**CNG FUELLING FACILITY, WATLING
STREET, HINCKLEY LE10 3ED**

CONSTRUCTION MANAGEMENT PLAN

**CONSTRUCTION MANAGEMENT PLAN
ON BEHALF OF CNG FUELS**

Rev	Issue Purpose	Author	Checked	Reviewed	Approved	Date
-	Draft For Comment	SO	MJB	SO	SRB	May. 24
A	For Issue	SO	MJB	SO	SRB	May. 24

P:\22-240 - CNG Watling Street, Hinckley\Tech\Acad\Drawings\22-240-007 - Proposed Left In Right Out Access.dwg

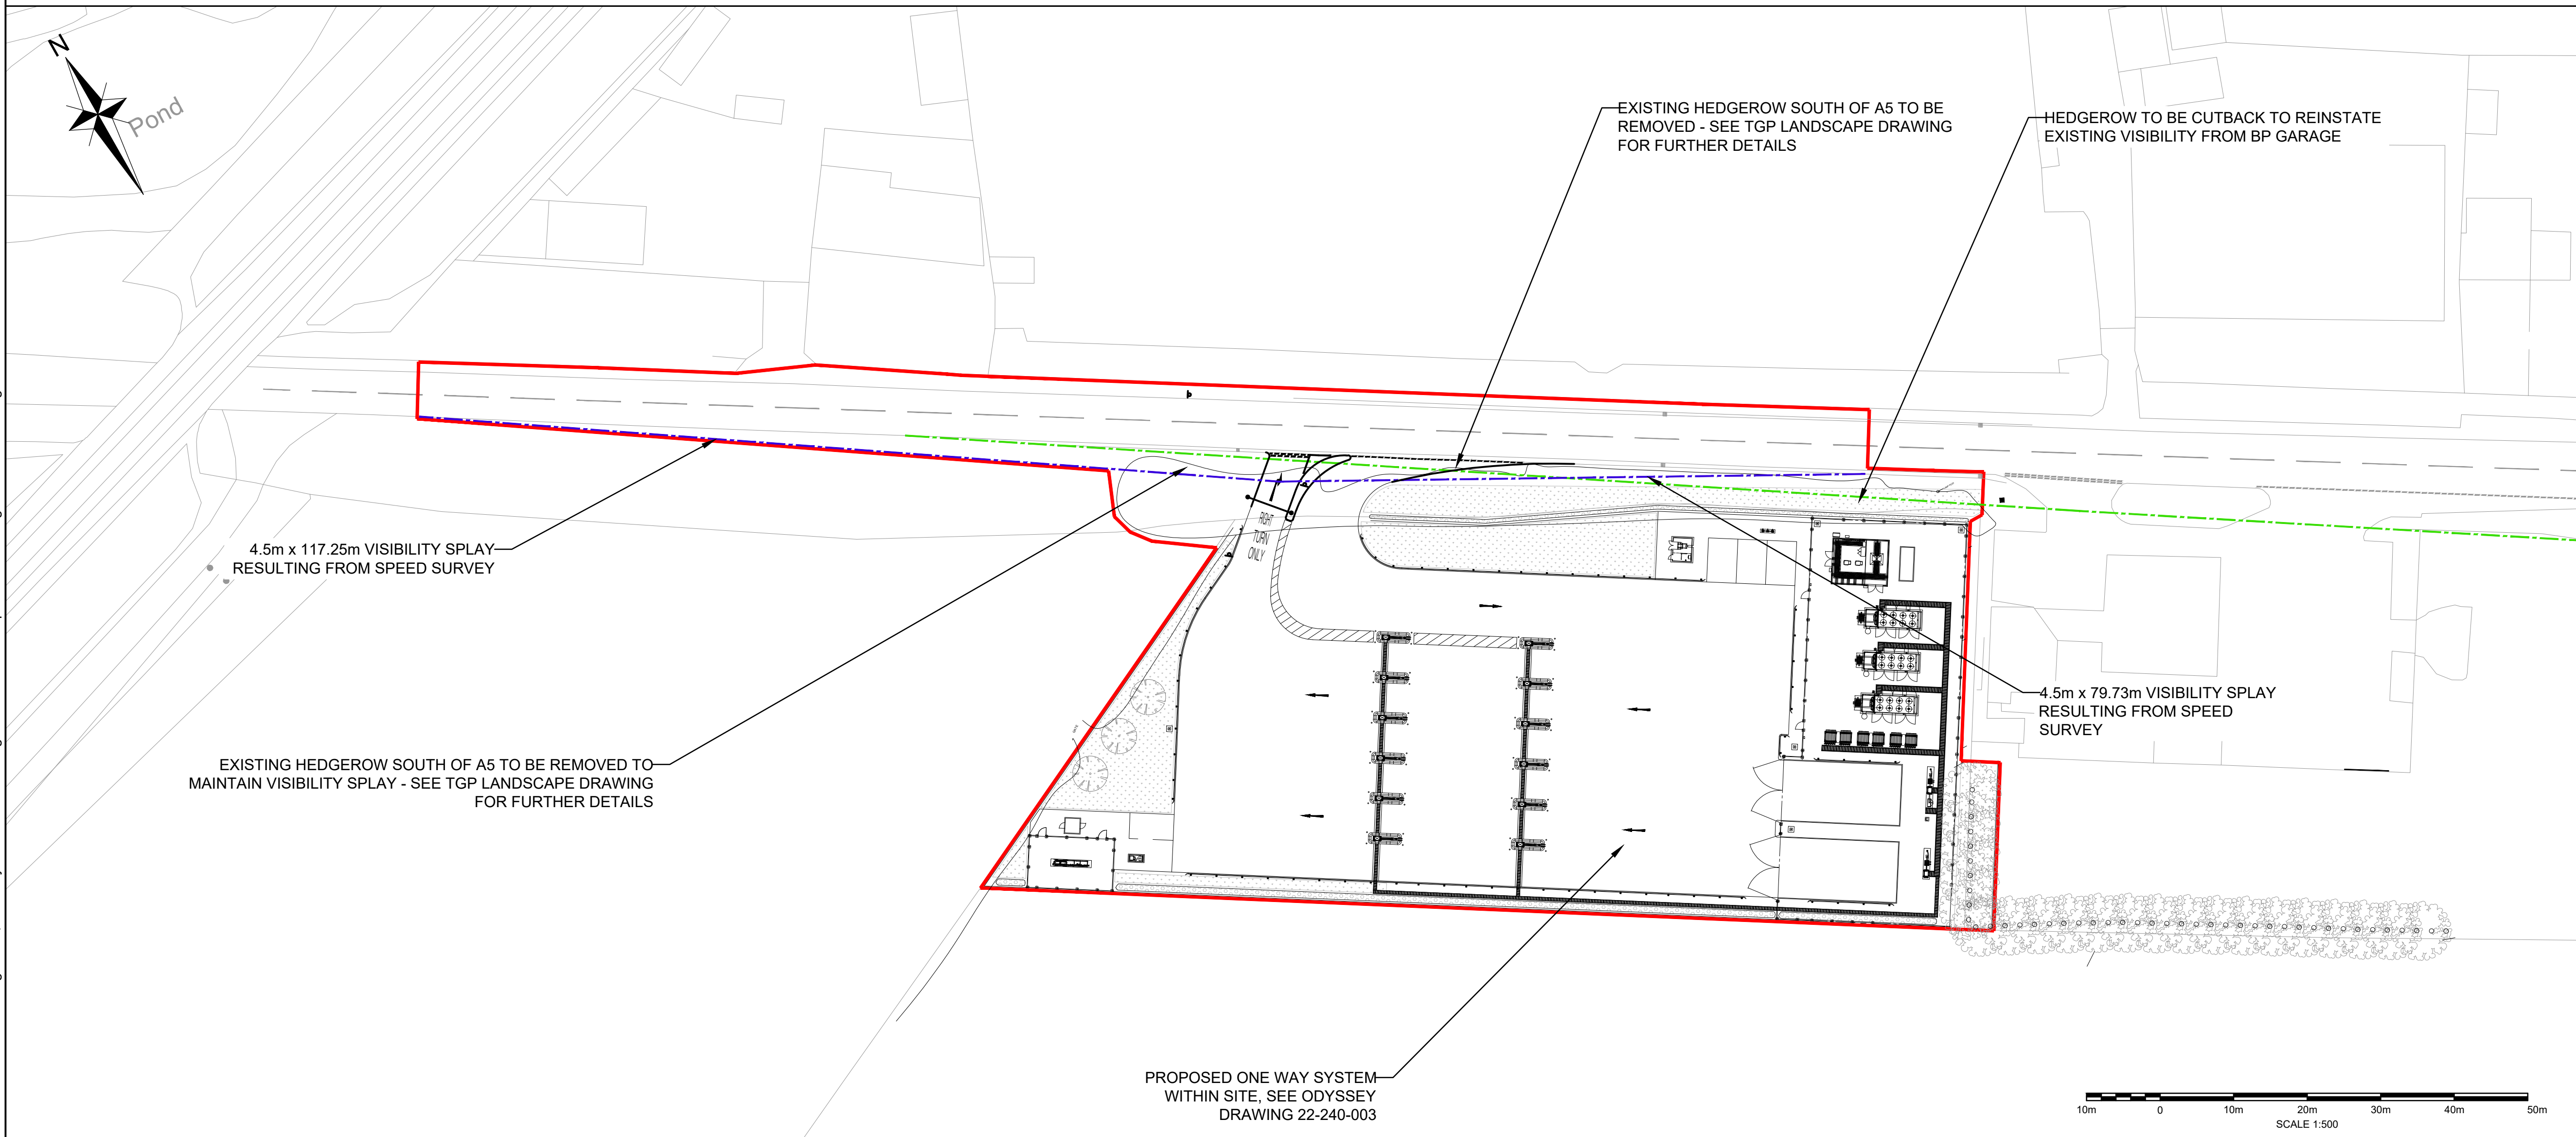
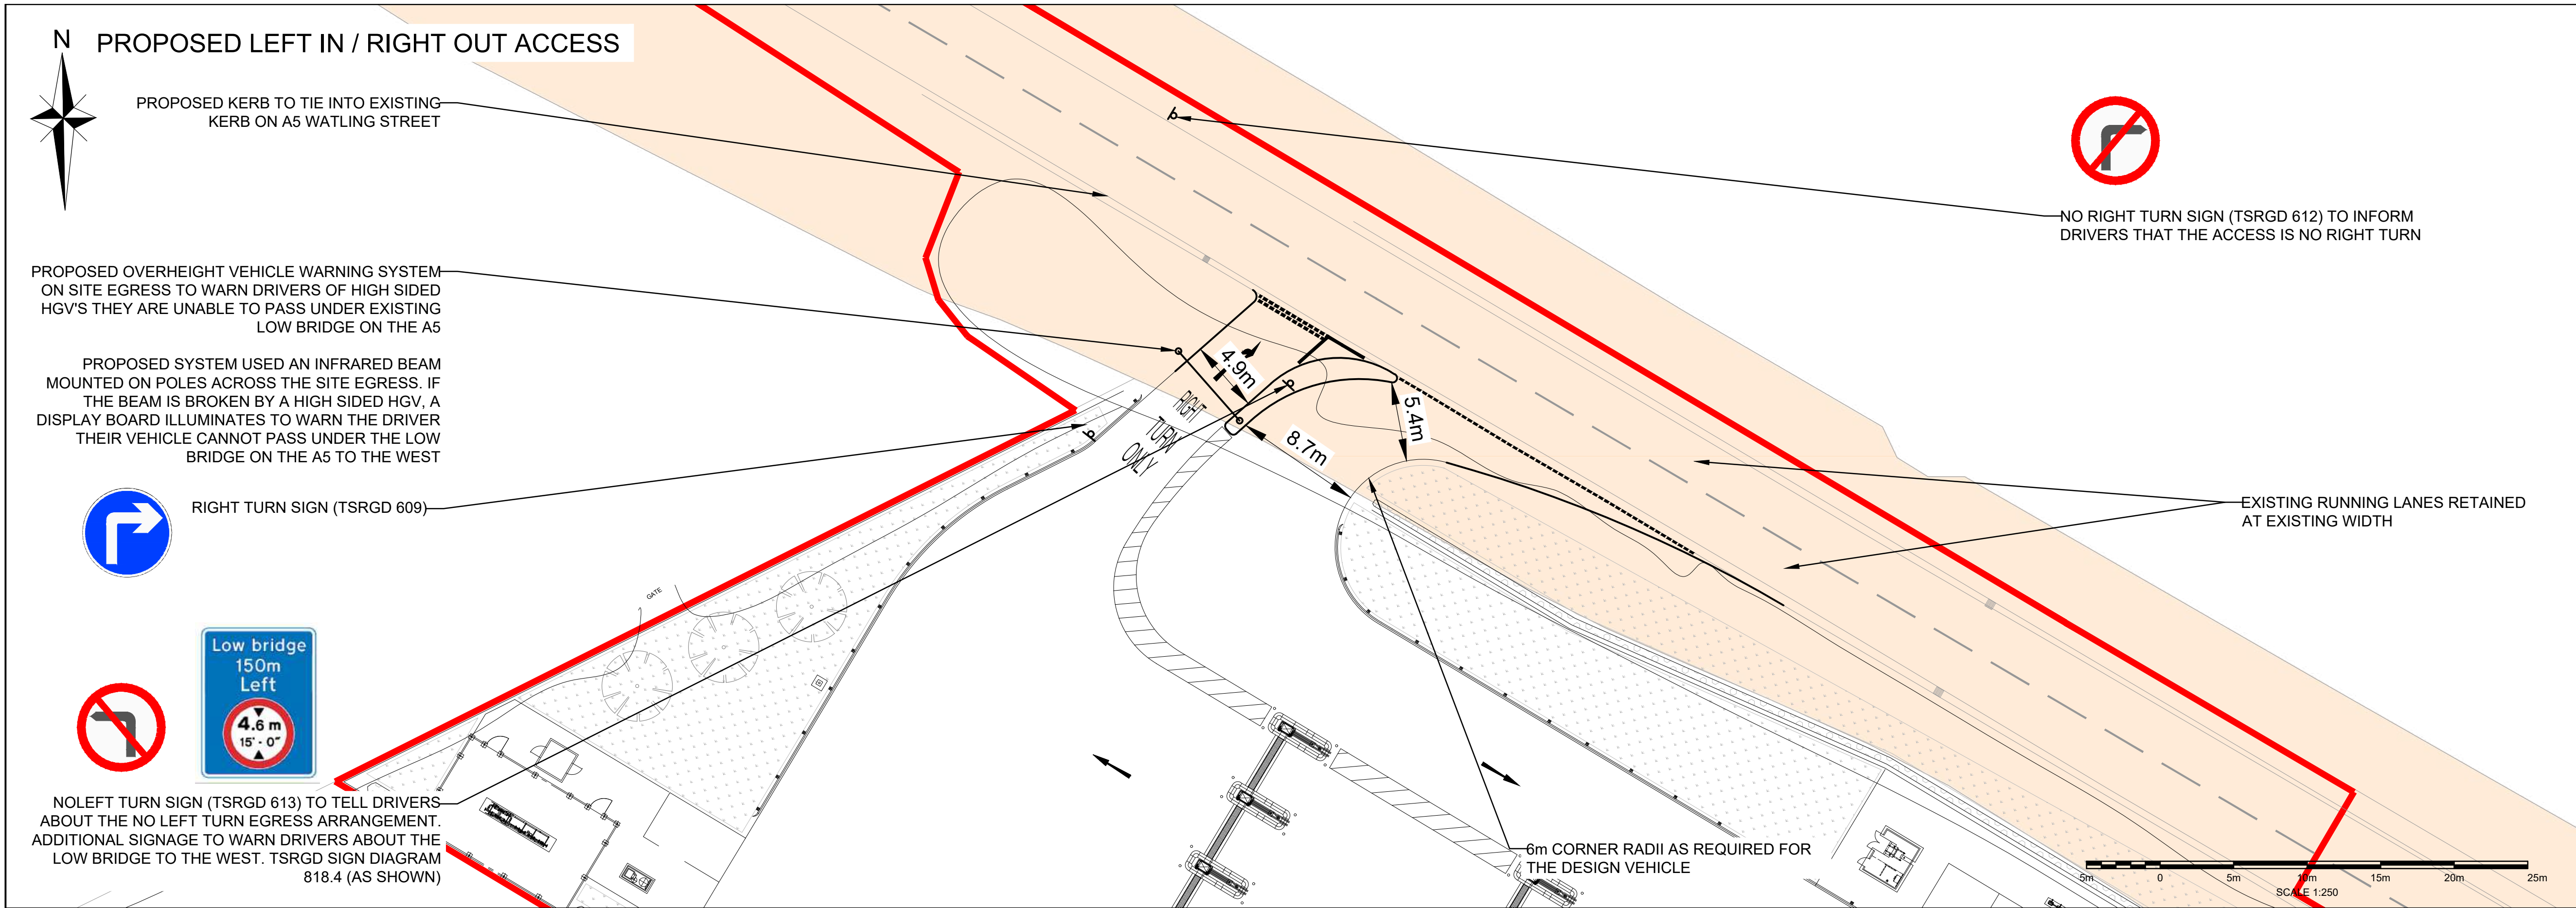
The Applicant previously proposed a ghost island right turn lane on the A5 to provide all movements access into the site to which the LHA and NH had significant concerns due to highway safety. The access has now been revised due to the location of the low bridge on the A5 Watling Street. The revised access now proposes a left in / right out only arrangement as demonstrated on Drawings 22-240-007C and 22-240-008C. It is understood that the access has been designed to prohibit vehicles from turning right into the site from the A5 via the use of a curved central island, which would physically prevent HGVs from making a right turn. The access would prohibit vehicles from egressing the site left onto the A5 as there would be no kerb radii to allow for this.

- National Highways previously requested the required visibility splay, noting the 50mph speed limit for this section of the Strategic Road Network (SRN), is 4.5m x 160m – as opposed to 4.5m x 120m which was stated in the applicants Scoping Note. An updated visibility splay has been provided to show 4.5m x 160m in drawing 22-240-001.
- National Highways has reviewed this drawing, which shows the visibility splay to the right when exiting the site to include the access to the adjacent service station, which is not permitted as stated in Design Manual for Roads and Bridges (DMRB). Based on the submitted information, it does not appear that a DMRB compliant junction could be delivered at this location.

2.2.2 Based on the comments received from LCC and NH Officers during the pre-application meeting, a revised access solution has been developed. The revised access proposes a left in, right out only arrangement (see attached **Drawings 22-240-007** and **22-240-008**). The revised access arrangement has been designed to prohibit vehicles from turning right into the site from the A5 via the use of a curved central island within the access road, which would physically prevent HGV's from making a right turn onto Watling Street.

2.2.3 The proposed access arrangements presented in **Drawing 22-240-007** would also prohibit and physically prevent vehicles from egressing left out of the site onto the A5 as there would be no kerb radii to allow for this. Instead, a small bullnose kerb with HGV bollard and/ or trief kerb would be provided where the proposed access ties into the A5. All vehicles egressing the site would instead be routed southeast towards the Hammond's Way roundabout, directly away from the A5 railway bridge.

2.3.4 The visibility splays are shown on the revised access **Drawing 22-240-007**. As shown on the drawing, the visibility splays do not extend beneath the railway bridge to the west and nor does the splay extend across the existing BP access to the east.

- We have redesigned the site access from the previously proposed ghost island arrangement to a left in, right out only priority junction. The priority junction has been designed to ensure that HGV's would not be able to turn left out of the proposed site and travel towards the bridge on the A5. Please see attached **Drawing 22-240-007** which shows the now proposed site access.

- As **Drawing 22-240-007** shows, the visibility splays from the proposed access do not crossover the adjacent access for the BP garage, nor do they go beneath the existing A5 bridge. These visibility splays have been determined using the results of an Automatic Traffic Counter (ATC) survey carried out on the A5 using an independent survey company. The results of the ATC survey are attached for review and will be submitted as part of the forthcoming Transport Statement Addendum. Given that the visibility splays would not cross over third-party land, we do not believe that a departure from standards would be required.

Scale 1:250 @ A1	Date SEPT' 23	Designed BEB
Drawn BEB	Checked MJB	Approved MJB
Job No 22-240	Drawing No 22-240-008	Rev E

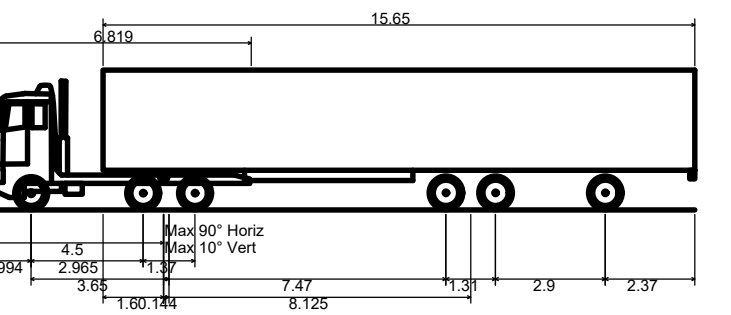
- Swept path analysis has been provided and is based on a 'CNG Specified Articulated HGV', with an overall length of 16.73m. This has been provided in drawings 22-240-002 and 22-240-003.
- Vehicular tracking in Drawing 22-240-003 shows the potential for stop/start/reversing manoeuvres and the potential for vehicle-to-vehicle conflicts. The applicant should clarify what is meant by this and address any conflicts.

- Vehicular tracking in Drawing 22-240-003 shows the potential for stop/start/reversing manoeuvres and the potential for vehicle-to-vehicle conflicts. The applicant should clarify what is meant by this and to address any conflicts.

- The swept path analysis drawings have been updated to take account of the new legal maximum size HGV's, these being 18.55 metres long. Please see **Drawings 22-240-008** and **22-240-003** which show swept path analysis of 18.55m HGV's manoeuvring in an out of the site access as well as accessing the pumps. We have also illustrated HGV's waiting/ refuelling within the site whilst another HGV manoeuvres through the site.
